Objection to Proposed CDM Credits for 24.75 MW Mahan-3 HEP

Upon reading the Project Design Document (PDD) Form version 1.0 dated March 4th, 2012 and visiting 24.75 MW Mahan Hydro Power Project site between May 16th, 2012 and May 23rd, 2012, we, the undersigned group of people concerned with the people and development of the area around the Mahan project and river in particular and the Indian state of Chhattisgarh, feel that CDM credits should not be granted for this project.

Annexure 1: Map of the close cluster of Mahan hydro projects

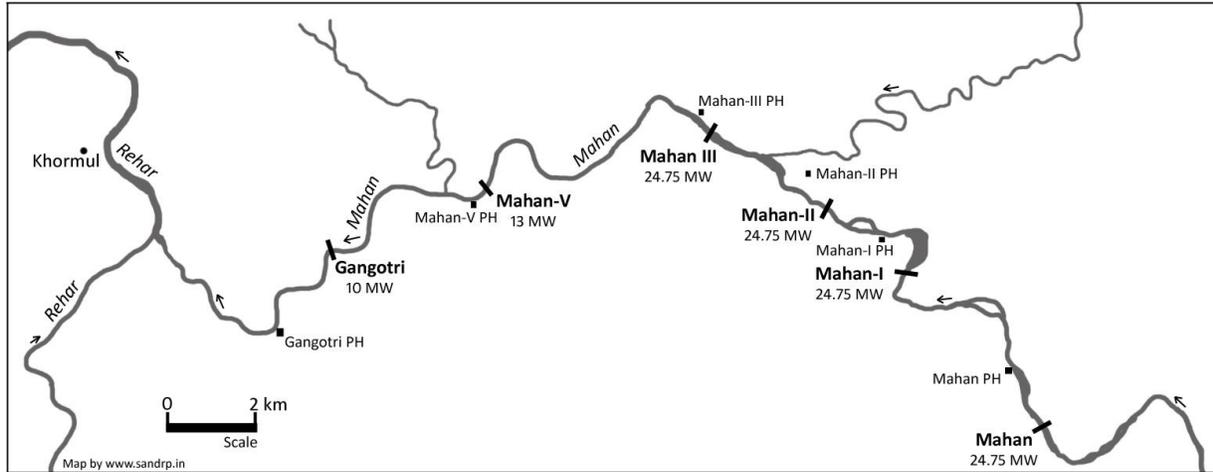
6. The project in question is part of a cluster of 6 hydro power projects—Mahan, Mahan-1, Mahan-2, Mahan-3, Mahan-5, Gangotri (totaling 122 MW, see map of these projects at *Annexure 1*). In addition to the project in question (Mahan-3), Venika Hydro Projects Private Ltd is pursuing three other 24.75 MW HEP projects and one other 13 MW HEP project—totaling 112 MW in this cluster. All of these projects will be constructed on the same stretch of the Mahan River, a tributary of the Rehar River, and are located within approximately 15 km of one another. The PP states that the project in question is “run-of-the-river” and therefore “benign”, but this is misleading as it fails to consider the cumulative impacts of the developer’s five HEP projects, in addition to the other projects on the river. UNFCCC should withhold CDM credit from the project until a rigorous Environmental Impact Assessment/Environmental Management Program is undertaken

(of Mahan-3) alongside an independent cumulative impact assessment of the six Mahan projects.
